Visual Differences Between Flex and DPA Bedbars

Product: Flex 21 & Triplex Cutting Units		September 29, 2008
Affected Units:	Models:	Serial Numbers:
Flex 21	04021	210000101-270009999
Flex 21 Cutting Unit	04200	210000101-270009999
Flex 21 DPA Cutting Unit	04202	260000101-280009999
Triplex DPA Cutting Unit	04610	230000101-280009999

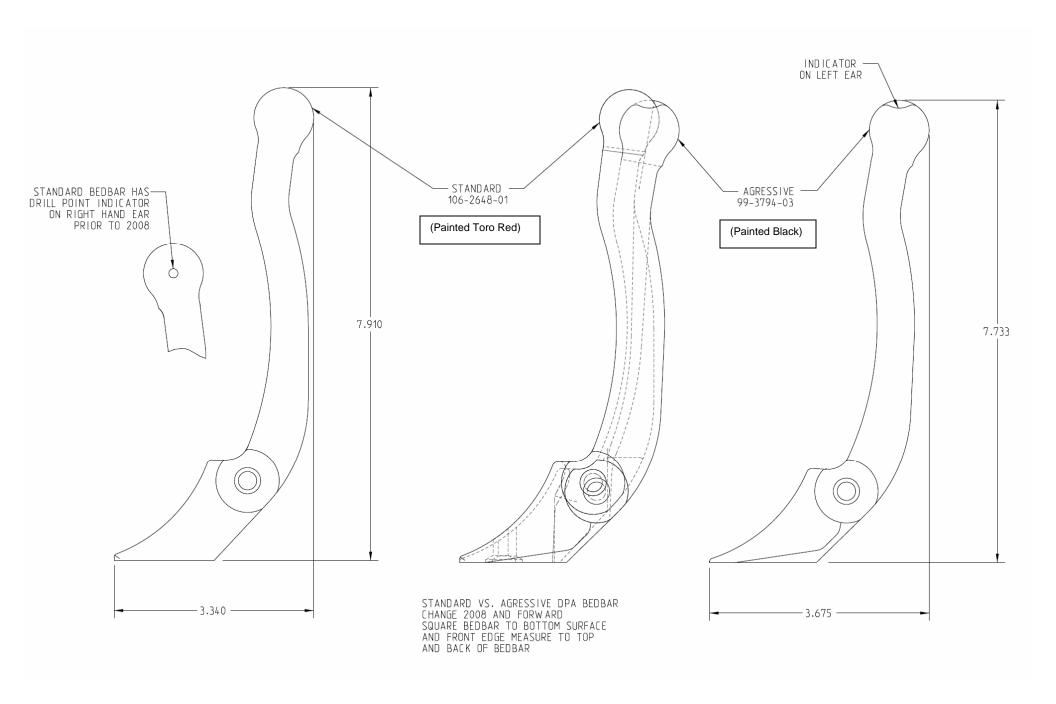
Aggressive Bedbar (99-3794-03) used in Flex 21 cutting units built between 2001 and 2006 (serial numbers 210000101-260009999) were painted red until serial 270009999. After that serial number, all factory installed Aggressive Bedbars are painted black. A crescent shaped portion of the left ear was removed to further visually differentiate it from the Standard Bedbar. (see attached diagram)

Standard Bedbar (106-2648-01) used in all DPA cutting unit applications (230000101 & newer) are painted Toro red. A drill point hole appears in all right ear locations in factory installed bedbars prior to 280000101. All Standard Bedbars produced in 2008 and newer will not have this drill point feature. All Standard Bedbars produced from 2008 and up will be identified solely by red paint.

The last two digits in the part number indicate the paint code color - in this example, -01 indicates Toro Red and -03 signifies black paint.
